Determination 2017/052

The refusal to issue a certificate of acceptance for recladding a 22-year-old building at 1/21 and 2/21 Sherborne Street, St Albans, Christchurch

Figure 2: Party wall junction

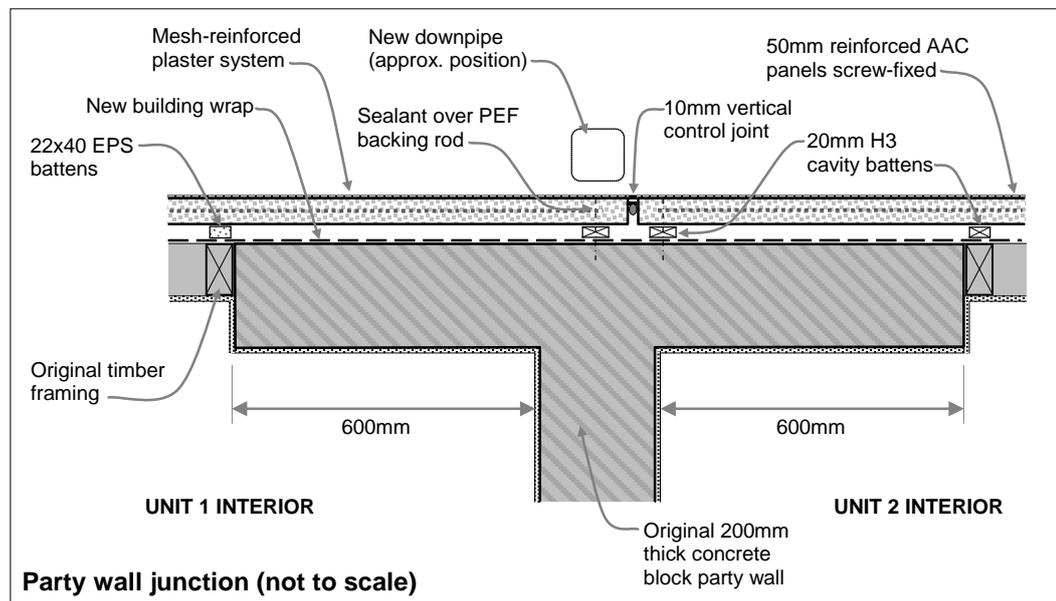
2.3.3 The manufacturer's 2010 'Technical Manual' ("the manual") set out requirements for vertical and horizontal control joints to be installed in walls exceeding 8m in length and height. Post-installation drawings¹⁰ include a detail of vertical control joints installed only at ends of the inter-party wall. Based on this detail together with the expert's on-site measurement, the as-built party wall junction appears to be as shown in Figure 2.

- the authority said it appeared that battens at the party wall appeared to be too small, but agreed that a construction photo would suffice as evidence of the size used

Figure 3: Guidance detail

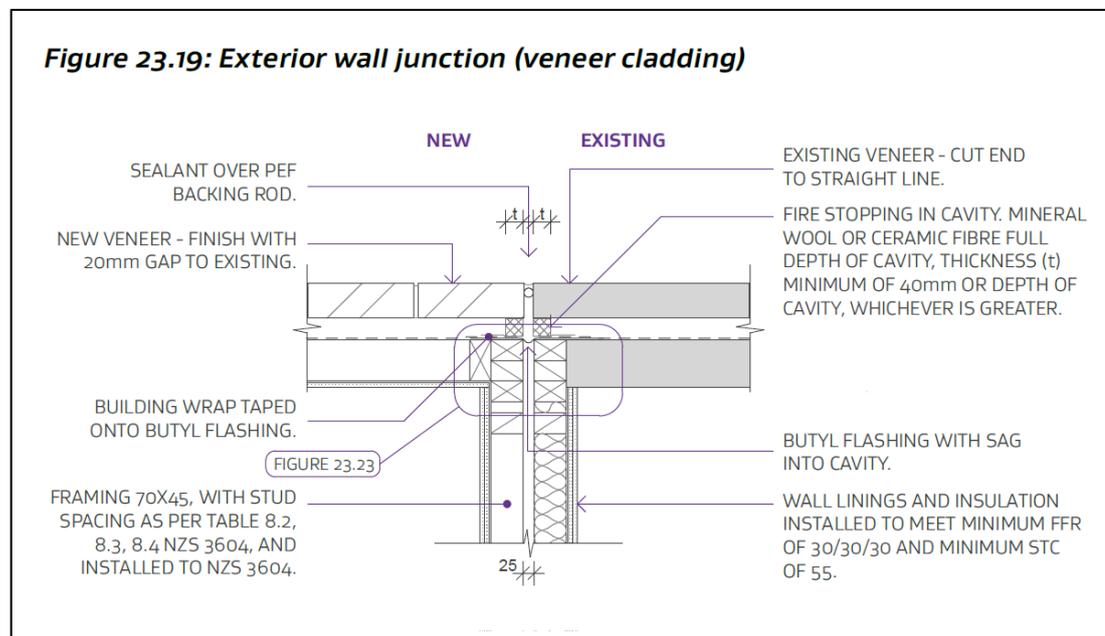
4.15.1 The authority is unwilling to rely on the builder's producer statement in regard to the party wall detail (see Figure 2), which shows 20mm deep battens in line with the cavity depth instead of 40mm battens as shown in a Ministry guidance detail¹⁶ (Figure 3). The authority requires a fire engineer's report.

4.15.2 The expert assessed the party wall, comparing this with Figure 3, and concluded that the as-built fire separation provides at least the same fire separation given that:

- the Ministry detail shows fire stopping in the 40mm cavity installed over flashing tape and a butyl strip, with timber-framing and fire-rated linings either side of the party wall cavity immediately behind
- although the post-construction detail D11 shows the 200mm concrete block party wall extending 400mm into each unit, interior drilling confirmed that the concrete block actually extends 600mm either side of the party wall – so, for a fire to spread between the units, it would have to burn through framing and battens and travel some 1.4m across the exterior of the blockwork.

Clause C3: Protection from fire		
Party wall end detail	<ul style="list-style-type: none"> Concrete blocks extend 600mm into each unit from party wall, meaning effective fire separation about 1.4m At least as good as guidance detail 	Complies
